Subject: Duke Energy Corporation
Catawba Nuclear Station, Unit 2
Docket Number 50-414
Proposed License Amendment
Revision of Unit 2 Reactor Coolant System Cold Leg
Elbow Tap Flow Coefficients

DESCRIPTION OF PROPOSED CHANGES AND TECHNICAL JUSTIFICATION

Figure 1

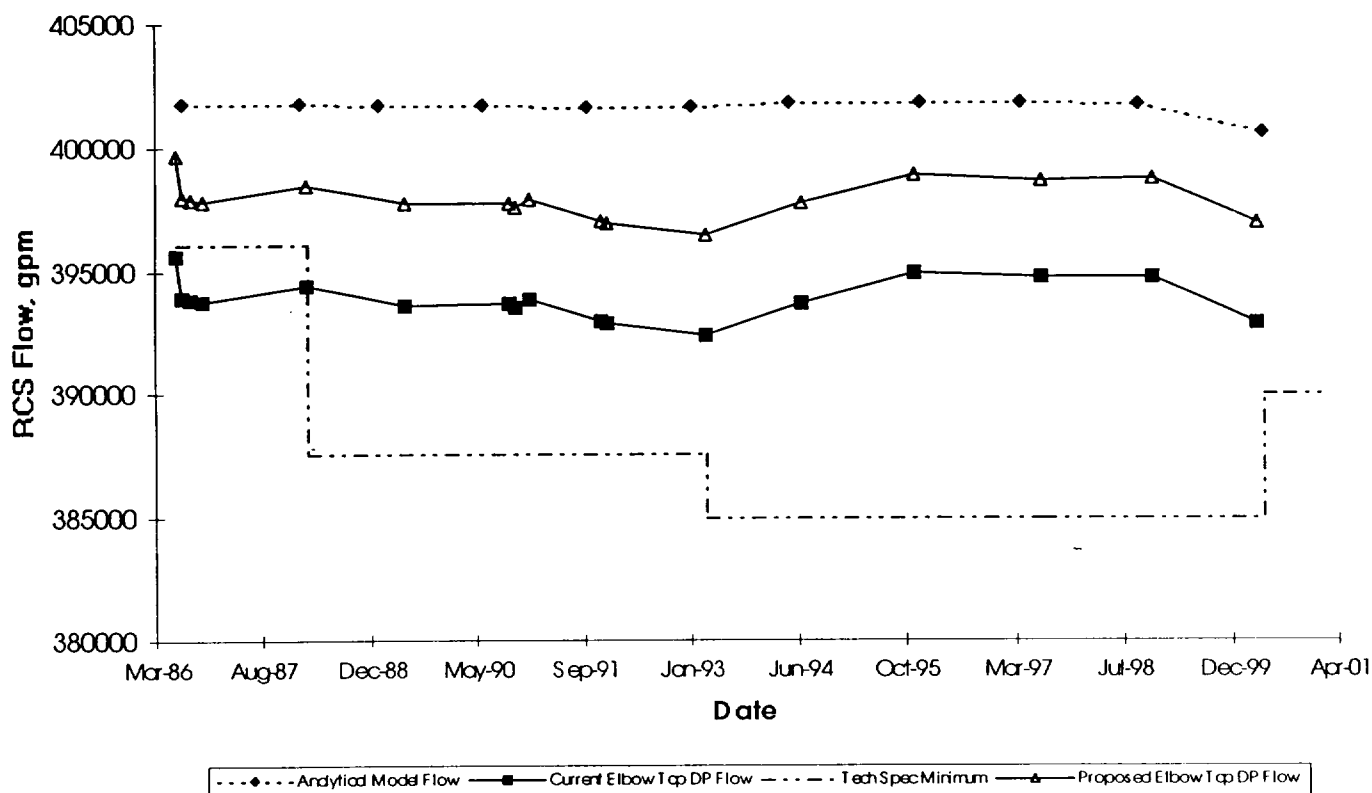
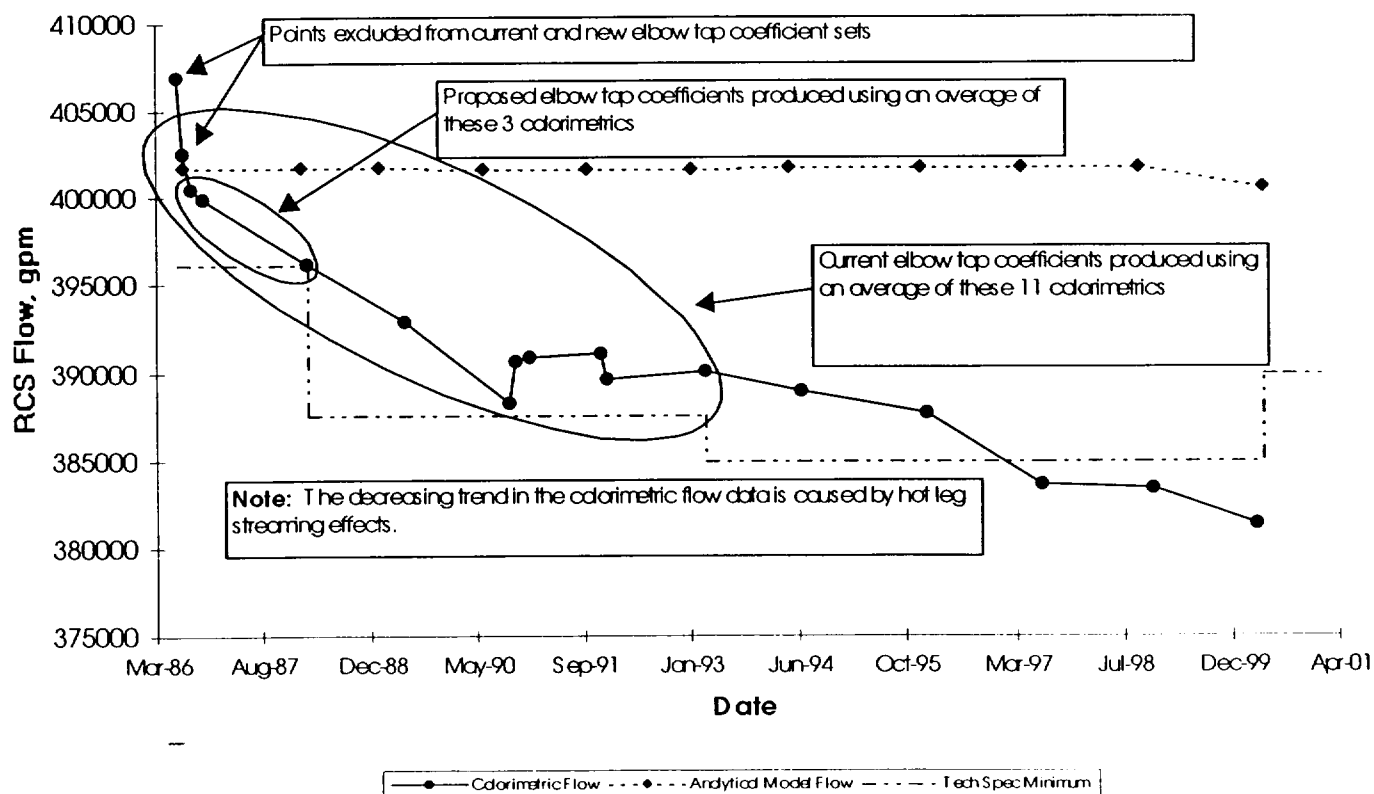
Using the delta P indications from the last RCS flow surveillance, and the new set of elbow tap coefficients, a new RCS flow rate of 396,907 gpm is calculated for the current cycle (Cycle 11). This represents an increase in the indicated flow rate of approximately 4,043 gpm or 1.0% of the Technical Specification minimum measured flow rate limit. Figure 1 shows the relationship between the current elbow tap indication of flow, the flow indication using the new elbow tap coefficients, and the analytical model prediction of flow. It can be seen that in Figure 1 the RCS flow using the new elbow tap coefficients generally mirrors the elbow tap flow using the current elbow tap coefficients, while providing approximately 1.0% additional flow margin. Figure 2 provides a plot of the Catawba Unit 2 calorimetric-determined RCS flow compared to the analytical flow model prediction of flow. In addition, this figure is annotated to describe the calorimetric-determined elbow tap coefficients used to determine the current averaged set of elbow tap coefficients and the new set of averaged coefficients.
